RESOURCE CONSERVATION AND RECOVERY ACT FACILITY INVESTIGATION WORK  
PLAN ADDENDUM ZONE H CNC CHARLESTON SC  
6/27/2001  
CH2M HILL

# RCRA Facility Investigation Work Plan Addendum – Zone H

Re: RCRA Facility Investigation Work Plan Addendum(Revision 1), Zone H, Charleston  
Naval Complex

**Figure 2-1**  
 Site Features and Sampling Locations  
 SWMU 136 and AOC 663, Zone H  
 Charleston Naval Complex

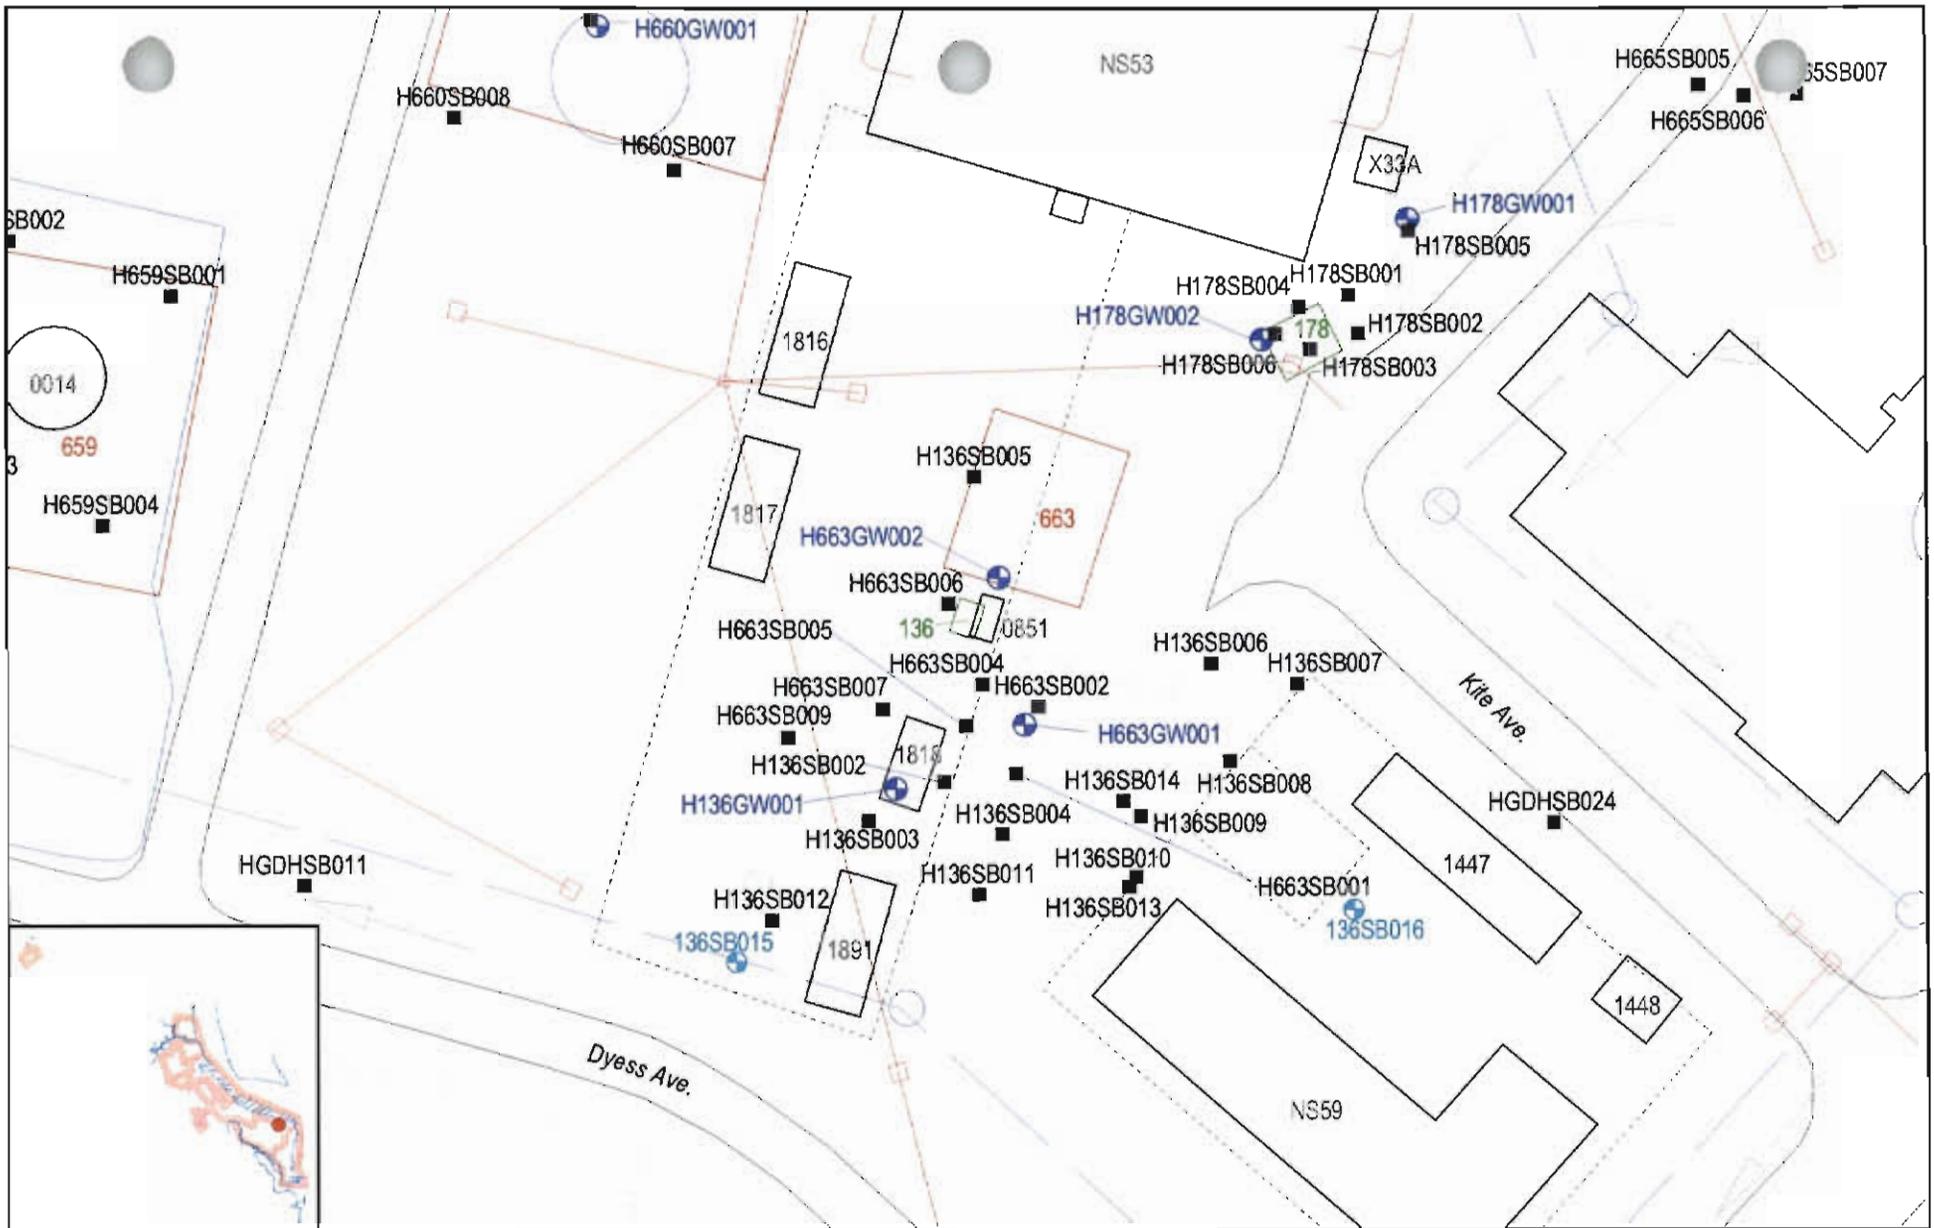
1. Section 2.2.2. Soil Data Gaps. Page 2-5.
  - Based on the Figure 2-1 the sample locations where the subsurface arsenic hits above background occurred are more that 130 feet away from the referenced SMWU and AOC.
  - There are numerous sample locations between the SWMU/AOC and location for arsenic hits that are below the background.
  - The background value for arsenic subsurface soil is 22.5 mg/kg. The two hits above were detected at 24.8 and 23 mg/kg. Based on the subsurface soil data and the location of the samples with respect to the site, additional subsurface soil sampling may not be necessary.

**Figure 2-7**  
**SWMU 17 RFI and Sampling Stations**  
 SWMU 17, Zone H  
 Charleston Naval Complex  
 Charleston, SC

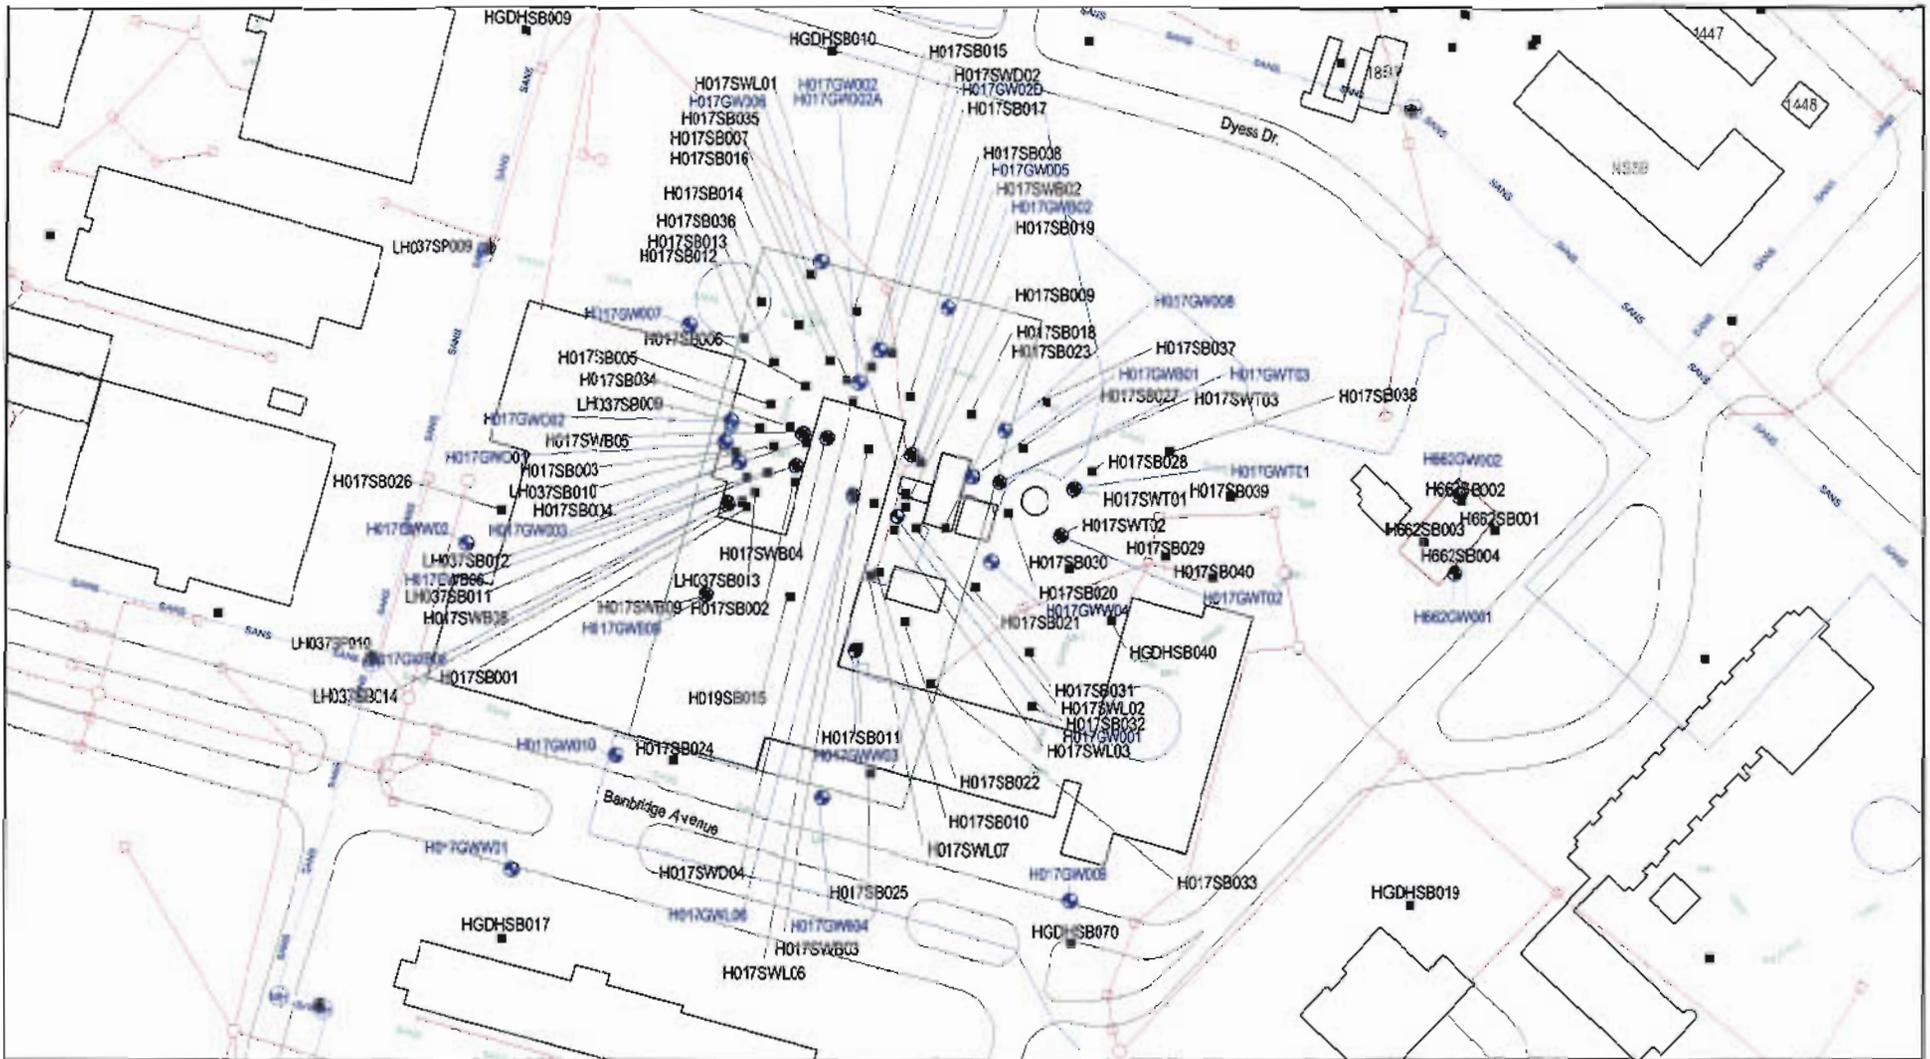
8. Figure 2-7. Please provide a legend table indicating the various well identification symbols used on this figure. For example: Provide the information regarding the difference between H017GWO02 and H017GW002 or H017GWB08 and H017GW008. Also provide the groundwater and surface water flow direction for this figure. This will help to expedite the review of the referenced RFI Work Plan.

The text states that the soil borings 017SWB02 and 017SWT02 are shown on figure 2-7. The location 017SWB02 was not located on referenced figure. Please revise as needed.

*Figure 2-7 will be updated.*

**Figure 2-9 - AOC 653**  
**Site Features and Sampling Locations, Zone H**  
 Charleston Naval Complex  
 Charleston, SC

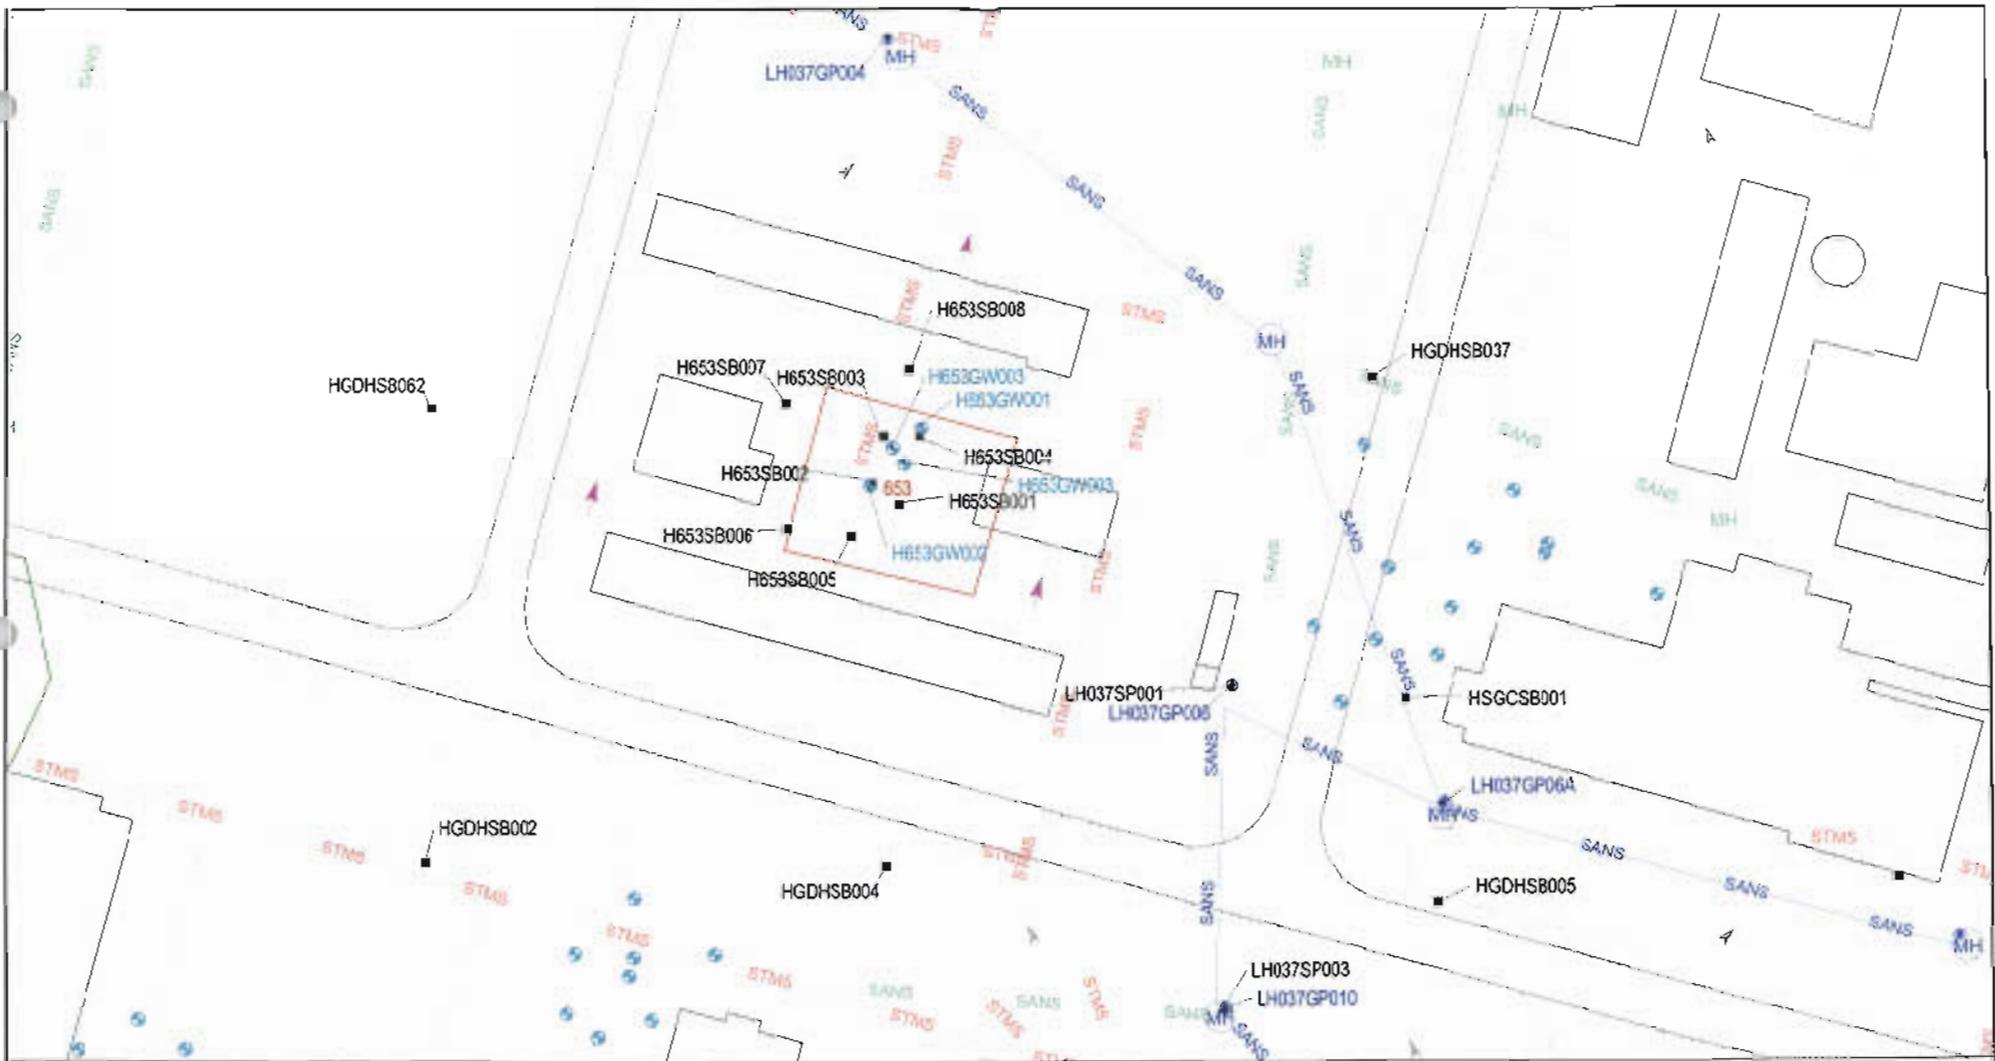
11. Figure 2-9. Please revise this figure to show all area that has been excavated. This would help to understand the current condition of the site for supporting the no further investigation and no further action decisions.

*A copy of Figure 4 of the AOC 653 Draft CMS Report, which shows the excavated areas, will be provided as an attachment to these responses to comments.*
